**07V-069
(15 pages)**

On Tuesday, January 21, 2007, U.S. Bus Corporation determined that a noncompliance with FMVSS 210 exists on certain U.S. Bus Corporation vehicles manufactured between 2003 and present; the actual number of released vehicles involved is (38).

Safety Defect and Noncompliance Report Guide for Vehicles
PART 573 Defect and Noncompliance Report¹

F.M.V.S.S. 210 SEAT BELT ASSEMBLY ANCHORAGES, TYPE 1, 2 TEST REPORT

210 ANCHORAGE TEST

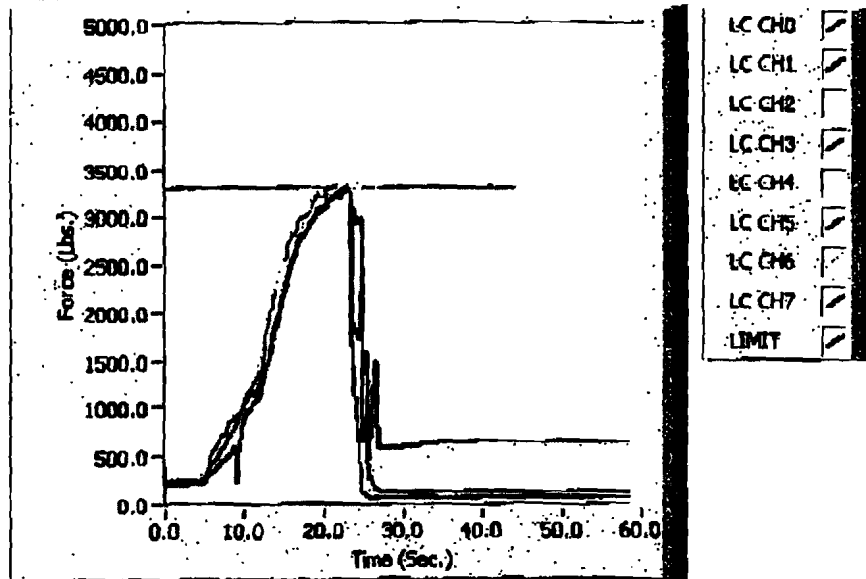
ADDITIONAL COMMENTS: 45" SSS US Bus buck track mount using shelok hardware w/grade 8 washers under nut head. 3 legs no wall mount.

CHANNEL	STATUS	PEAK FORCE (LB.)
0	FAIL	3277.08
1	FAIL	3285.55
2	FAIL	3454.59
3	FAIL	3344.04
4	PASS	4310.27
5	NOT ACTIVE	0.00
6	FAIL	3471.03
7	NOT ACTIVE	0.00

A must Re-test

USB0373

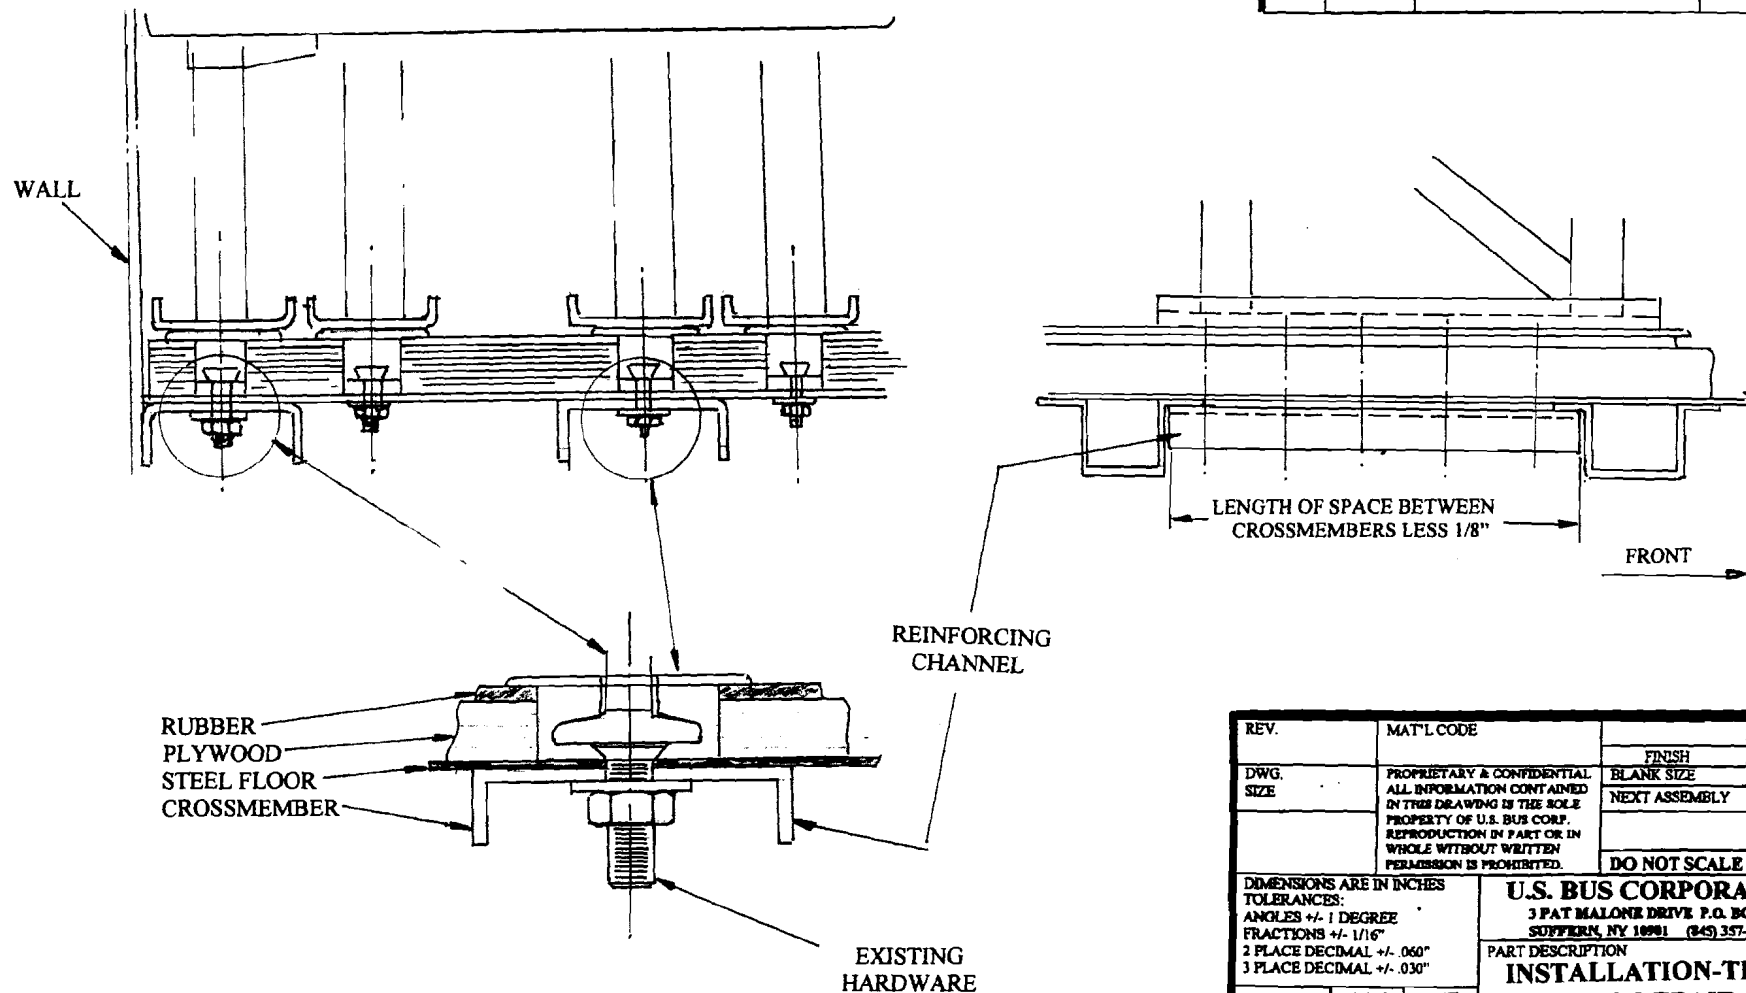
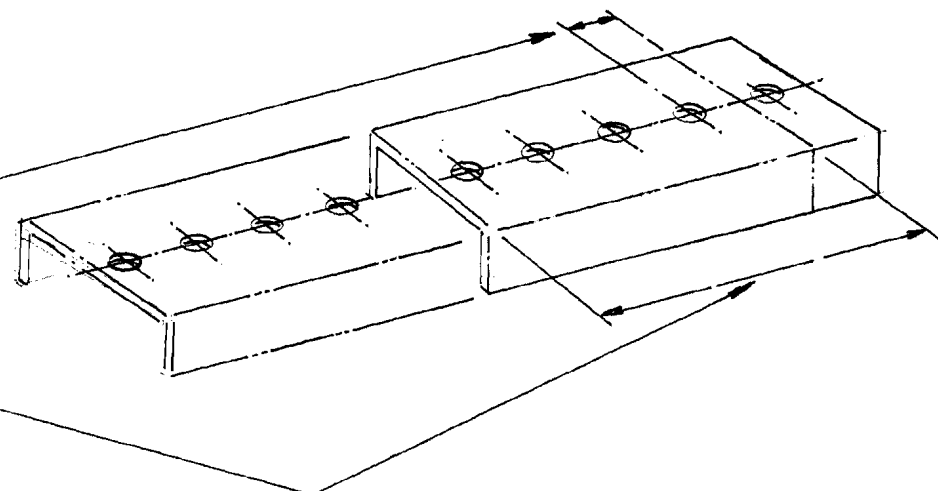
(2) STRUCTURAL CHANNELS BOLTED TO UNDERSIDE OF FLOOR.

SEE ATTACHED DRAWING

1. REMOVE ALL 45-INCH TRACK MOUNTED SEATS
2. REMOVE NUTS AND WASHERS HOLDING FIRST AND THIRD TRACKS FROM WALL, FROM UNDERSIDE OF BUS
3. MEASURE FROM FRONT CROSSMEMBER TO FIRST SCREW, MARK REPAIR CHANNEL.
4. MEASURE DISTANCE BETWEEN CROSSMEMBERS, AND MARK CHANNEL FOR LENGTH.
5. CUT CHANNEL WITH POWER HACKSAW OR PLASMA CUTTER.
6. SLIP CHANNEL OVER TRACK SCREWS, DRILLING 7/16" DIA. HOLES AT ANY SCREW NOT LINING UP WITH HOLE IN CHANNEL.
7. REINSTALL TRACK HARDWARE, MAKING SURE TO TIGHTEN ALL NUTS
8. REPLACE EXISTING SEAT ATTACHMENT DEVICES HOLDING SEATS TO TRACKS WITH REPLACEMENT DEVICES.
9. INSTALL ADDITIONAL SEAT LEGS WITH FASTENERS PROVIDED. LEG WITH OFFSET TOP BRACKET GOES ON TRACK NEAREST WALL.

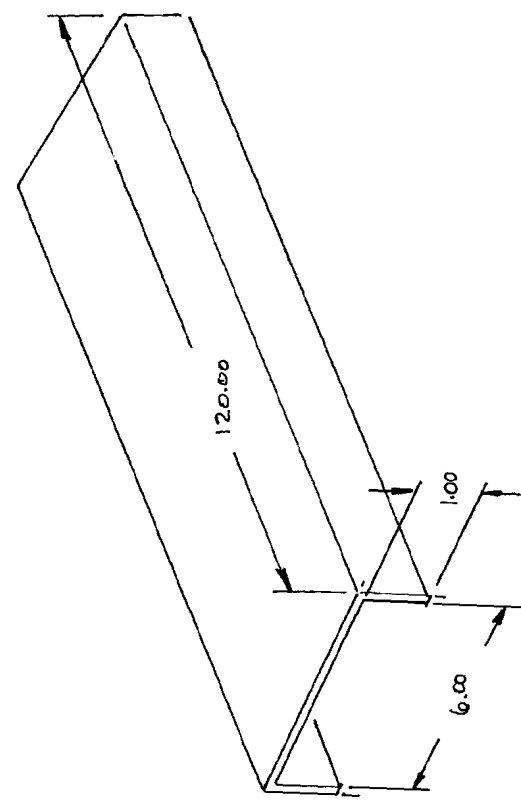
ATTACHMENT OF STRUCTURAL MEMBERS TO UNDERSIDE OF FLOOR.

12 GA. (.1084) GALVANIZED
STEEL
